TECHNICAL INFORMATION

E. Title : L8180 Series/ET-8550 Series Abnormal Sound and Paper feeding problem on R-ASF

ET-8500 / ET-8550 / L8160 / L8168 / L8180 / L8188

Fig.1 SPUR GER,22.4

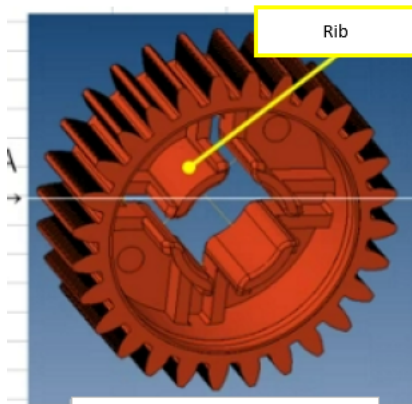
(Direct cause) The amount of gear(SPUR GER,22.4 of D/E) engagement is not enough

One of the causes was that the inner diameter rib of the gear opened toward the outer circumference due to the shrinkage effect during part molding (this is out of spec). This results in a tilt.

Changed the mold structure to assume opening due to shrinkage (adding a taper assuming opening)
